Letter from C. R. Steinhardt (WPSC)

Document Control Desk (NRC)

May 14, 1998

Proposed Amendment 155

Figure 1 - HEJ Sleeve Terminology (corresponds to numbered text, pg 6)

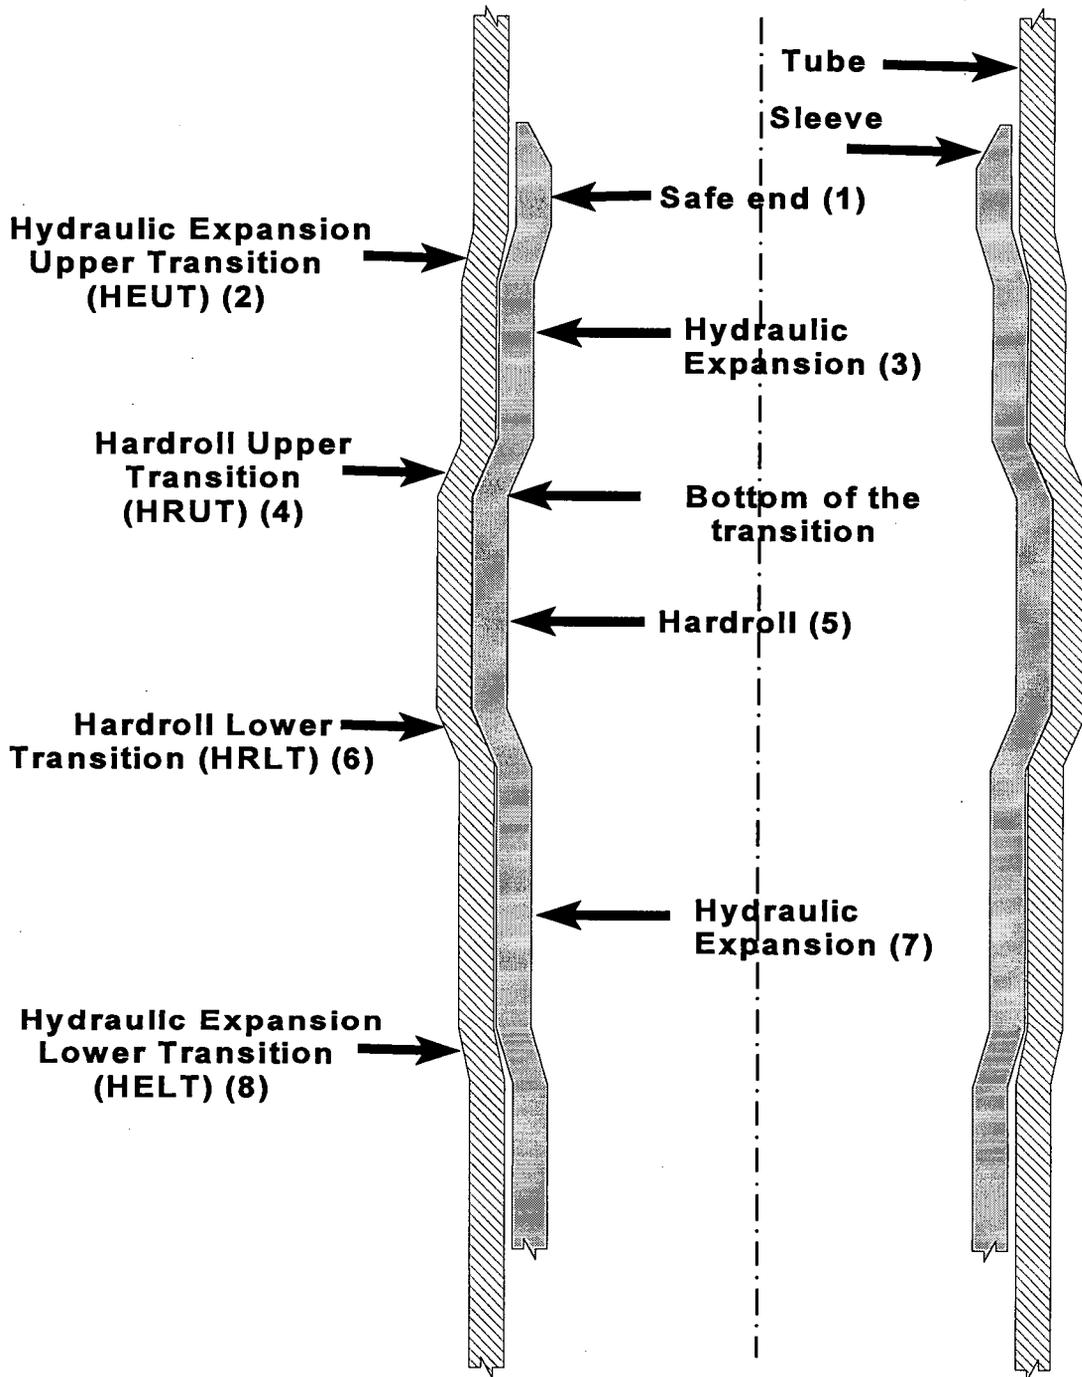
Starting from the upper end of the sleeve and moving downwards, the regions of the upper HEJ sleeve-to-tube joint assembly are as follows (refer to figure 1, page 16):

- (1) The non-expanded safe end, approximately 0.5 inch long,
- (2) The upper transition from the non-expanded to the hydraulically expanded region (HEUT),
- (3) The upper hydraulically expanded region, approximately 1 inch long,
- (4) The expansion transition from the hydraulically expanded region to the upper hardroll joint (HRUT), approximately 0.25 inch long,
- (5) The upper hardroll (HR) joint, approximately 1 inch long,
- (6) The expansion transition from the hardroll joint to the hydraulically expanded region (HRLT), approximately 0.25 inch long without roll down, or approximately 0.5 inch with roll down,
- (7) The lower hydraulically expanded region, approximately 1.5 inches long, and
- (8) The lower transition from the hydraulically expanded to the non-expanded portion of the sleeve (HELT).

Figure TS 4.2-1

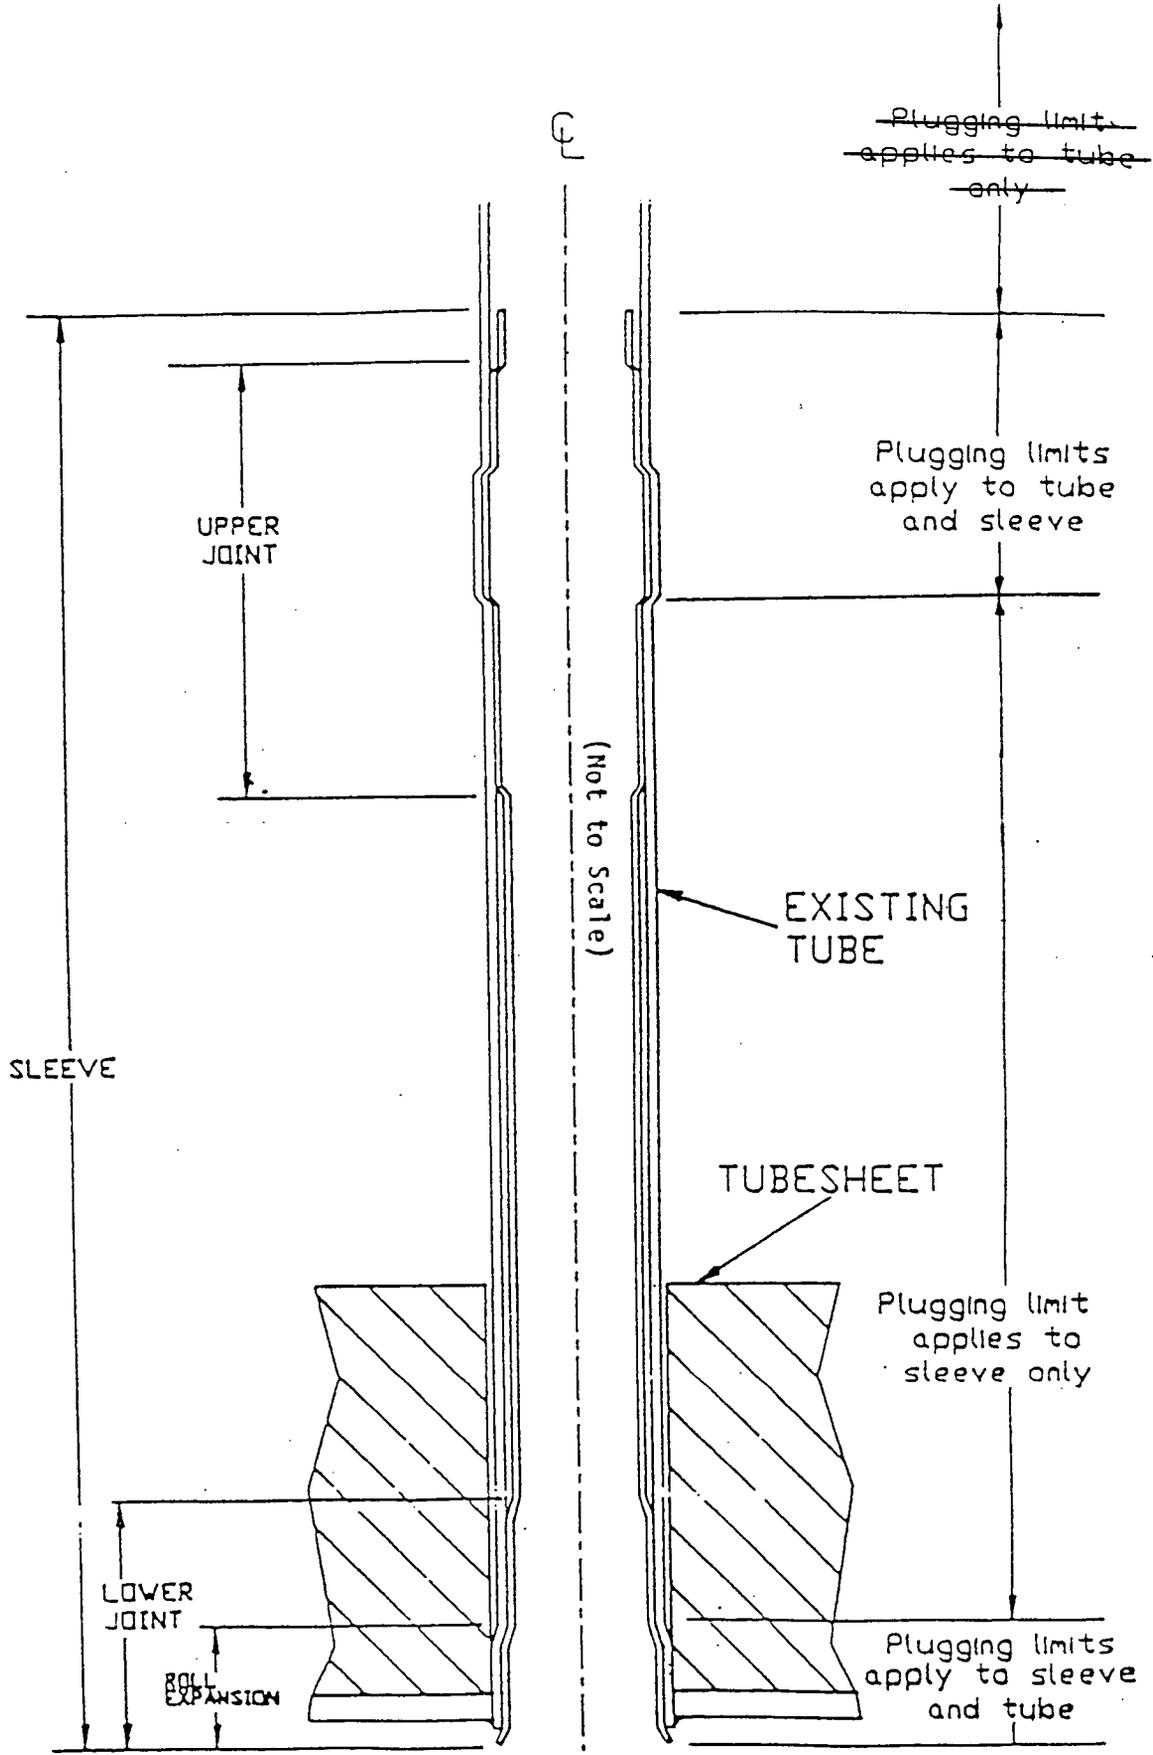
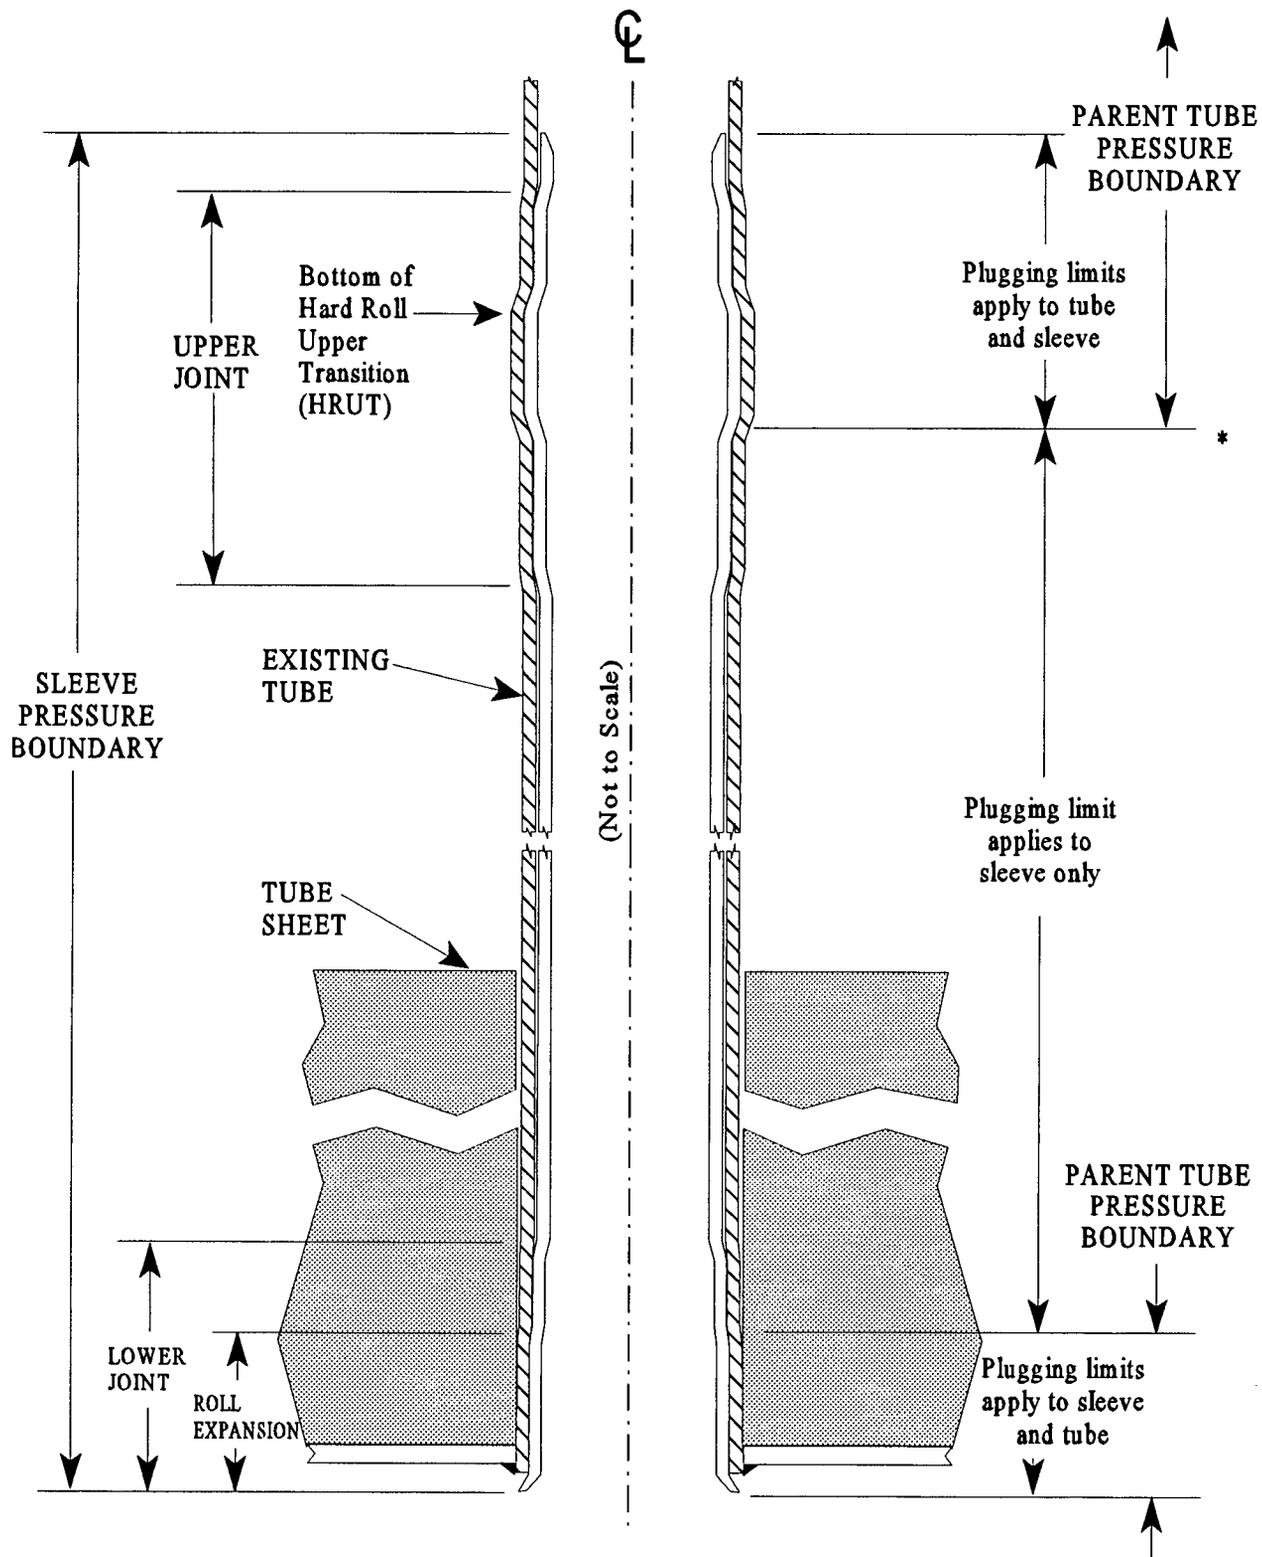
- c) HEJ sleeved tubes with axial parent tube indications located in the parent tube pressure boundary, as depicted in Figure TS 4.2-1, shall be plugged or repaired prior to returning the steam generator to service.
- 5) Figure TS 4.2-1 will be revised to depict the bottom of the hardroll upper transition, to revise the TS referenced at the bottom of the figure, and to define the sleeve and parent tube pressure boundaries more clearly.
- 6) Notes 1 and 2 of Table TS 4.2-2 will be updated to reference the correct TS.

- c. For disposition of parent tube indications in the upper joint of Westinghouse HEJ sleeved tubes, as depicted in Figure TS 4.2-1, the following requirements will apply:

3. HEJ sleeved tubes with axial parent tube indications located in the parent tube pressure boundary, as depicted in Figure TS 4.2-1, shall be plugged or repaired prior to returning the steam generator to service.

The pressure boundary for HEJ sleeves is shown on Figure TS 4.2-1. The pressure boundary used to disposition parent tube indications (PTIs) detected in the upper joint of HEJ sleeved tubes is discussed in WCAP-15050.⁽⁵⁾ The pressure boundary described in the WCAP will allow PTIs located in the upper joint to remain in service if there is a minimum non-degraded (i.e., no detectable degradation in the parent tube) hardroll length of 0.92 inch (plus an allowance for NDE uncertainty) as measured from the bottom of the hardroll upper transition. The minimum hardroll engagement length is derived from structural and leakage testing. During field application, the PTI is located in reference to the bottom of the hardroll upper transition to ensure the minimum length of non-degraded hardroll exits. The inspection is performed using eddy current techniques capable of profiling and flaw detection as described in "NDE Technique to Determine Length Measurements in HEJ Sleeved Tubes with Parent Tube Indications."⁽⁶⁾ The NDE uncertainty for this criterion is a function of the eddy current probe and technique used. The uncertainty has been calculated to be 0.023 inch. However, for field application, an eddy current uncertainty of 0.03 inch will be applied to the minimum hardroll engagement length of 0.92 inch.
